# STAFF REPORT

SUBJECT: H-2020-0064  
Pura Vida Ridge Ranch

LOCATION: 3727 E. Lake Hazel Rd., in the NW ¼ of  
Section 4, T.2N., R.1E  
Parcels: S1404212550 & S1404212750

## F. Parking Exhibit (REVISED)

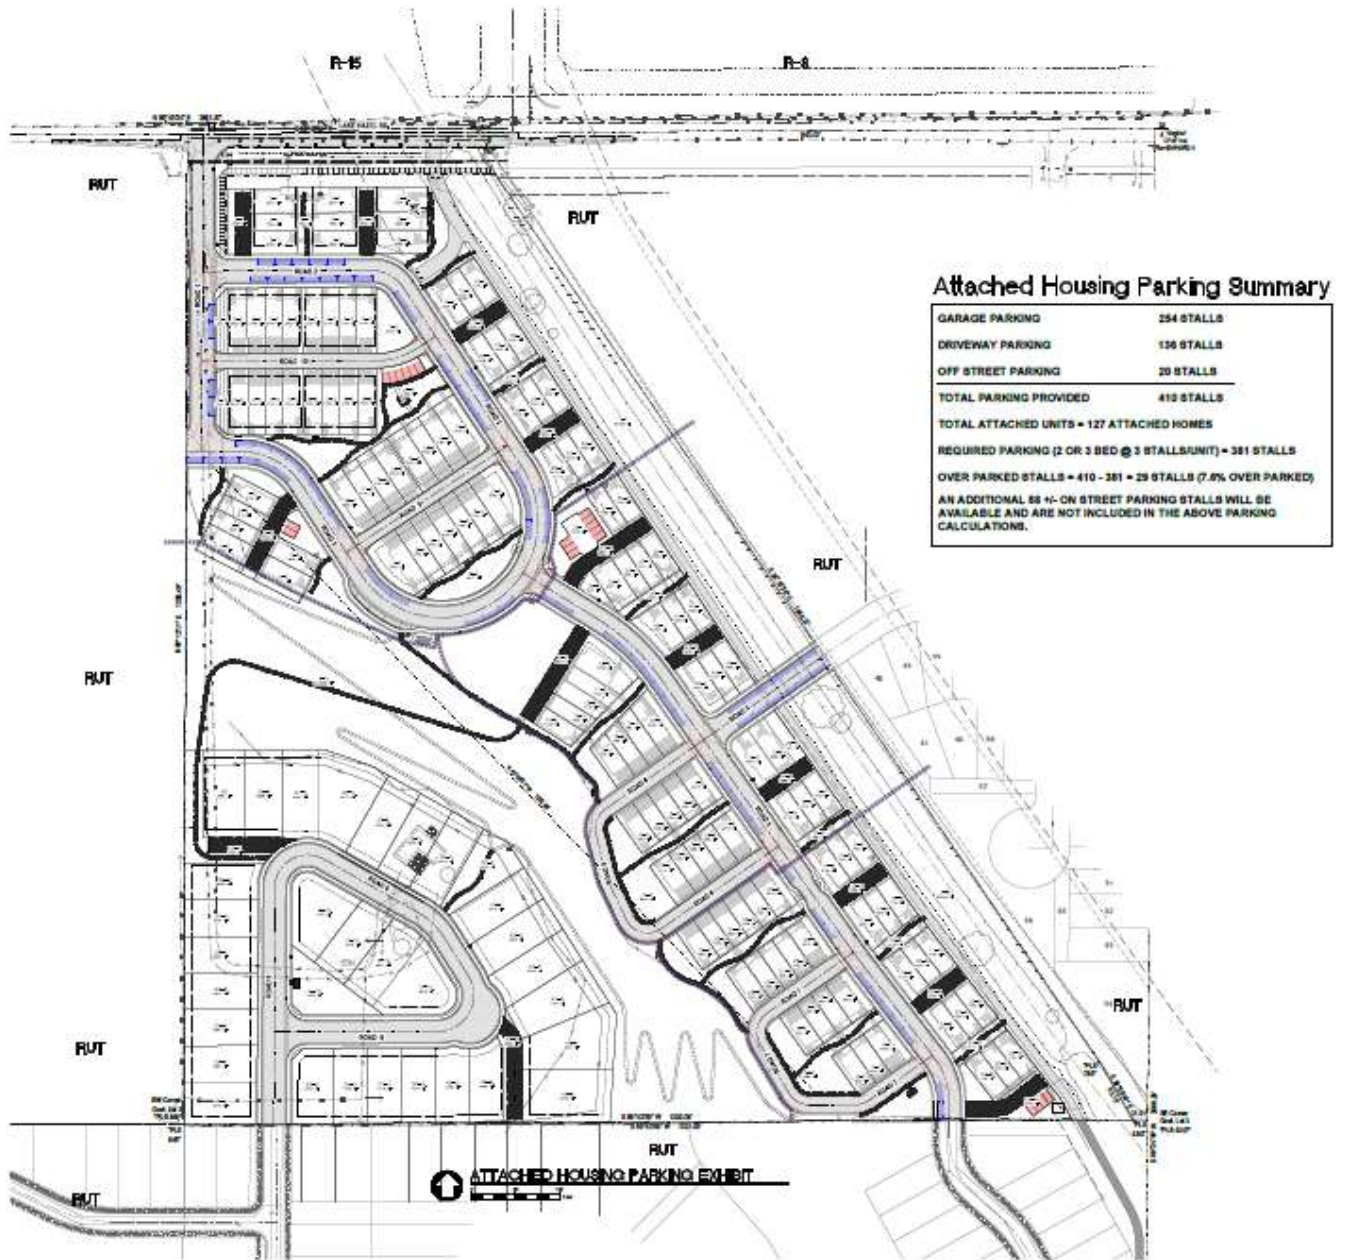
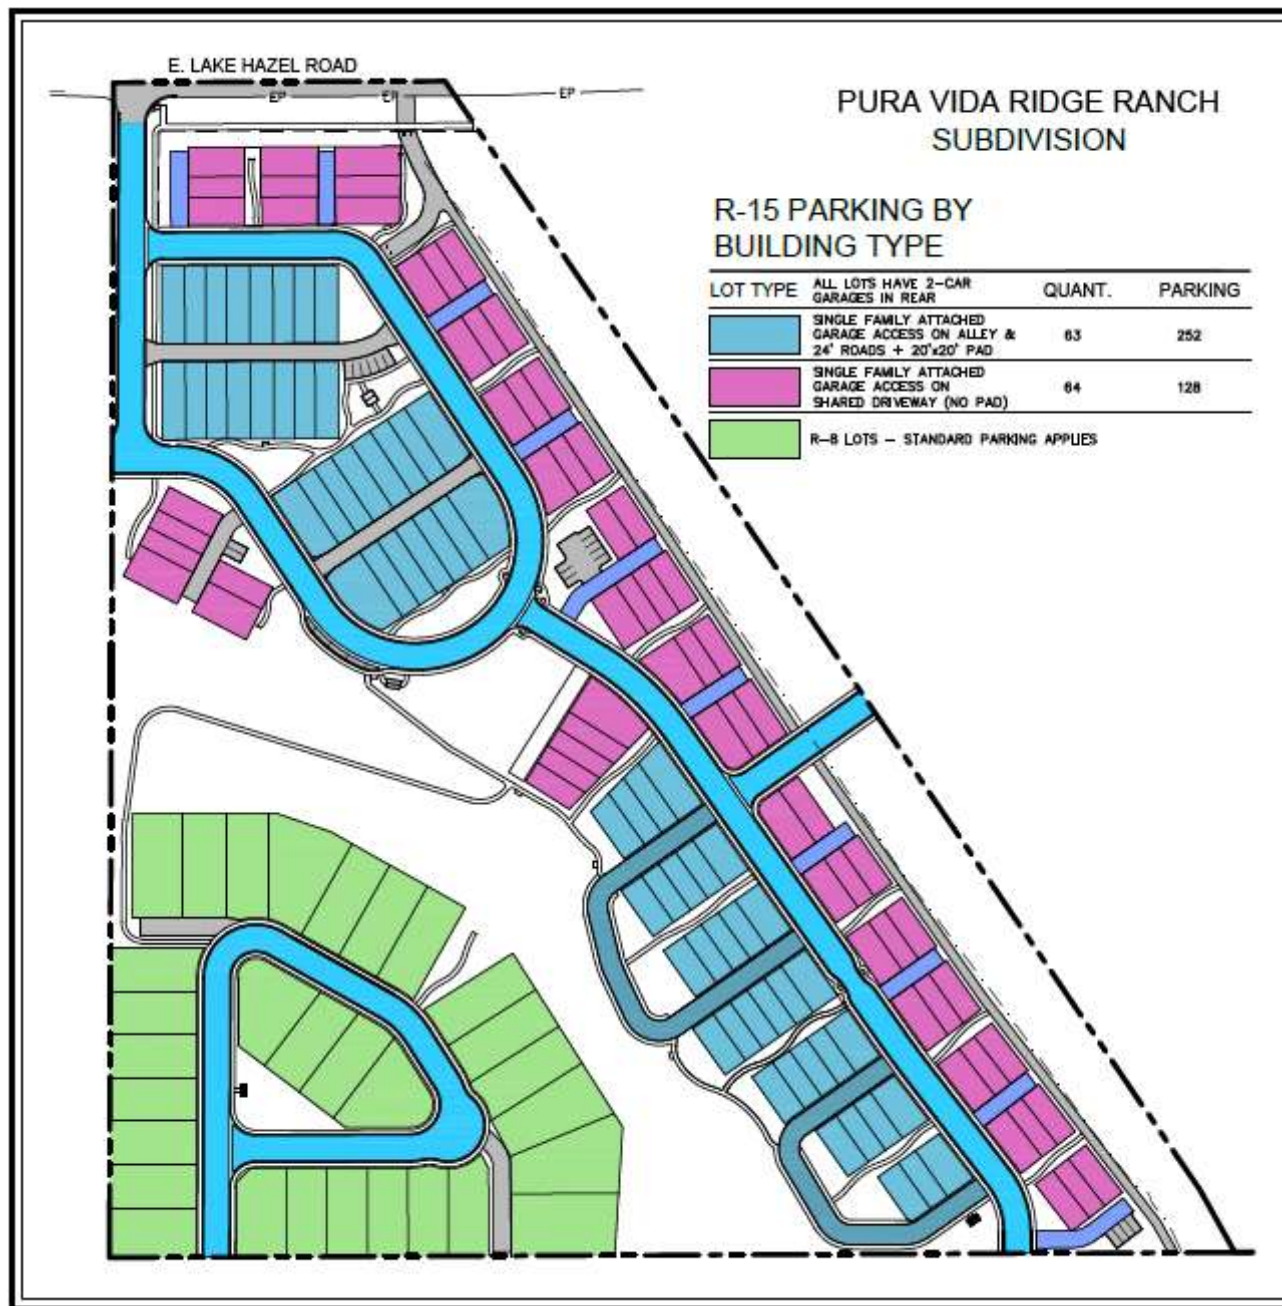
**The Applicant is proposing 20’ long x 18’ wide parking pads, which are 2’ less in width than required. The parking pads should be revised to be 20’ x 20’ in accord with UDC Table 11-3C-6.**

16. The parking pads for individual lots shall be revised to be 20' x 20' in accord with UDC Table 11-3C-6.
17. An exception was approved to UDC 11-3A-17D, which requires sidewalks to be constructed on both sides of all public streets, to only require sidewalks along the east sides of the 24 27' wide street sections (i.e. Roads 4, 6 and 7) adjacent to the parking areas as depicted on the Pedestrian Connectivity Plan in Section VIII.G *and* as required by ACHD (i.e. extend the sidewalks on the east sides of Roads 4 and 6 along the entire common lot/parking area).

**G. Pedestrian Connectivity Plan (dated: 11/23/20) - REVISED**

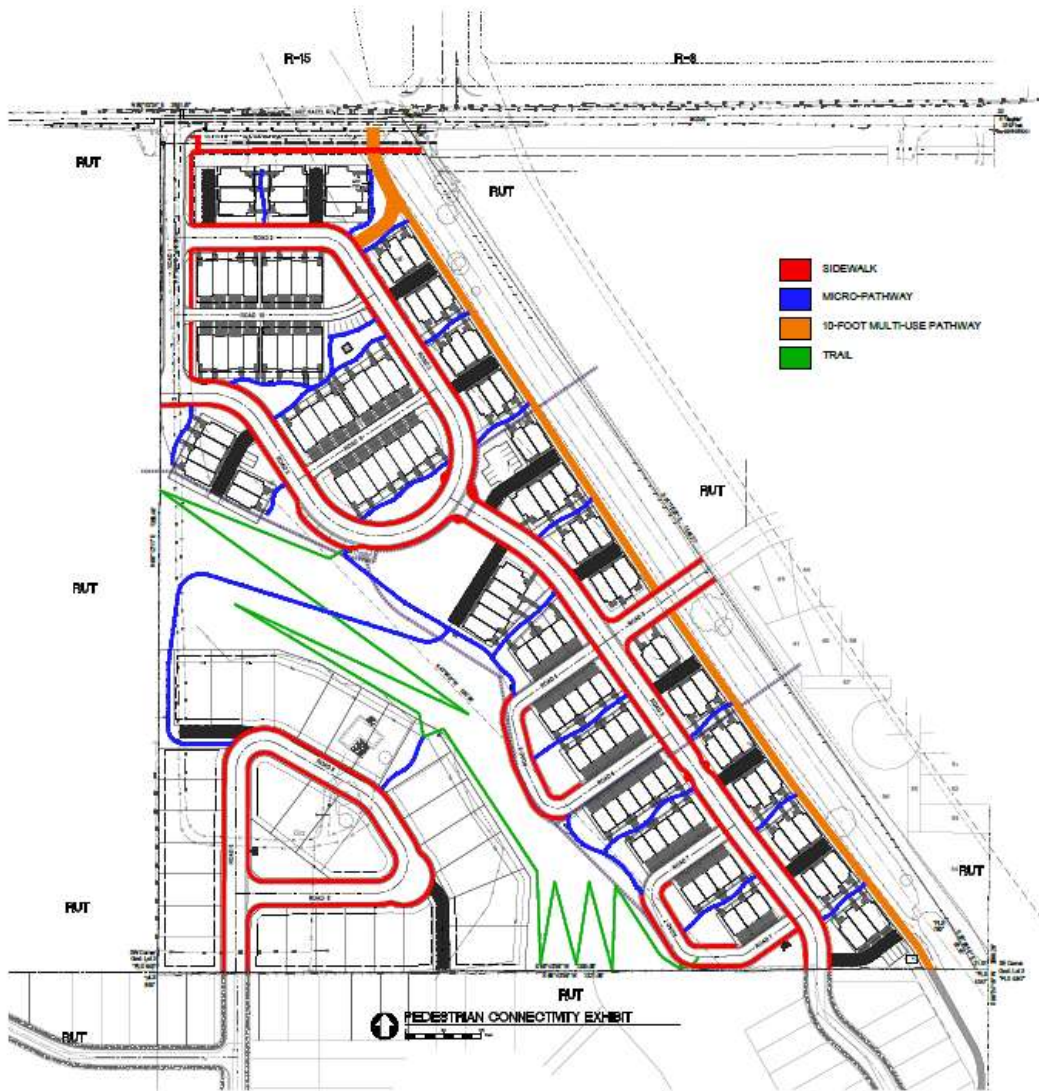
- UDC 11-3A-17D - Sidewalks are required to be provided on both sides of all public streets. Sidewalks are only proposed to be provided along the east sides of the 24' wide street sections (i.e. Roads 4, 6 and 7) adjacent to the parking areas as depicted on the Pedestrian Connectivity Plan in Section VIII.G. ACHD is requiring the sidewalks be extended on the east sides of Roads 4 and 6 along the entire common lot/parking area.
